AUDIO SYSTEM

■ DESCRIPTION

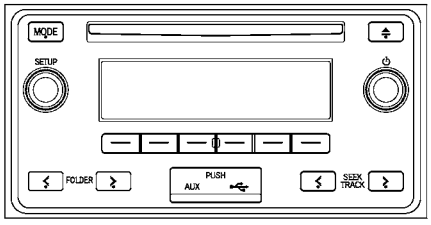
- The audio specifications for the destinations shown in the table below have been changed.
- A 3-line VFD (Vacuum Fluorescent Display) has been adopted to the audio display to improve operability such as track selection.

▶ Antenna Locations ◀

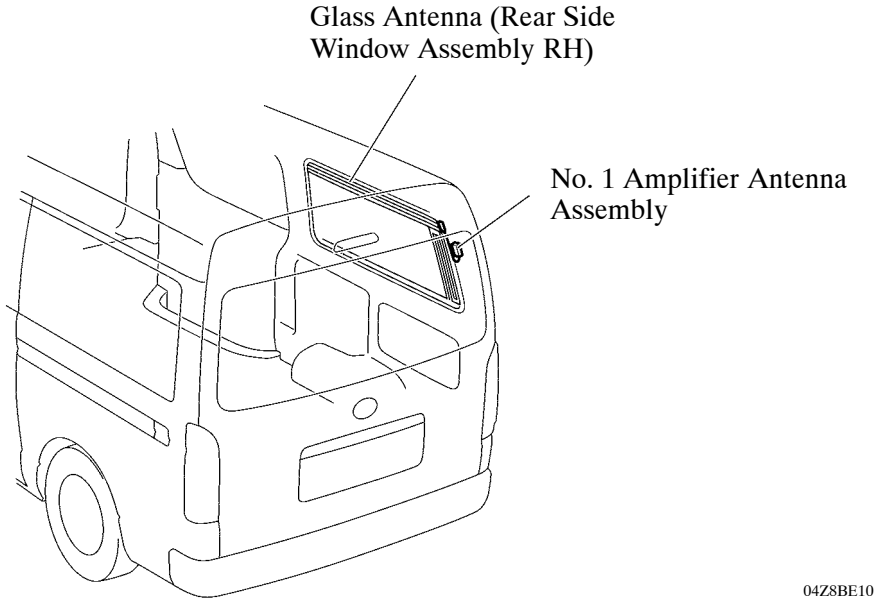
A glass antenna (rear side window assembly RH) has been adopted on the quarter window on the right side of the vehicle of some models. This improves the appearance and eliminates the necessity to fold the antenna when parking in a low ceiling space.

3. USB Jack and AUX

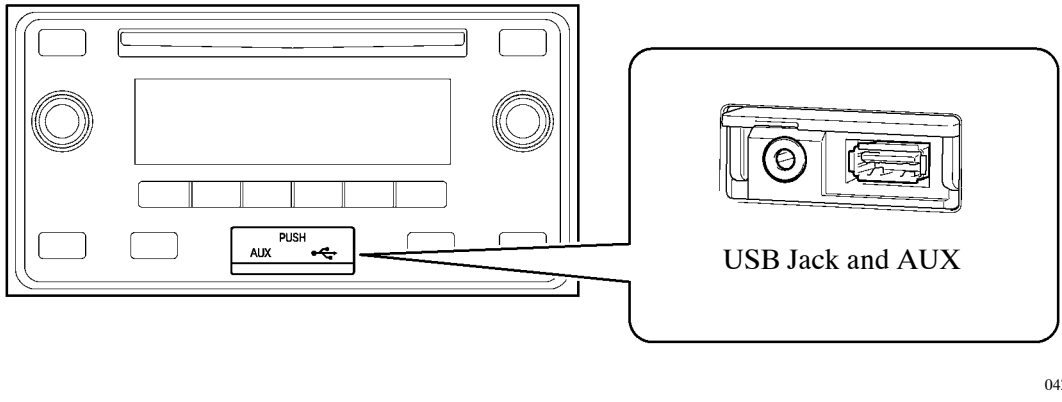
A USB jack and an external input terminal (AUX) have been provided at the bottom center of the audio panel, making it possible to operate external equipment.
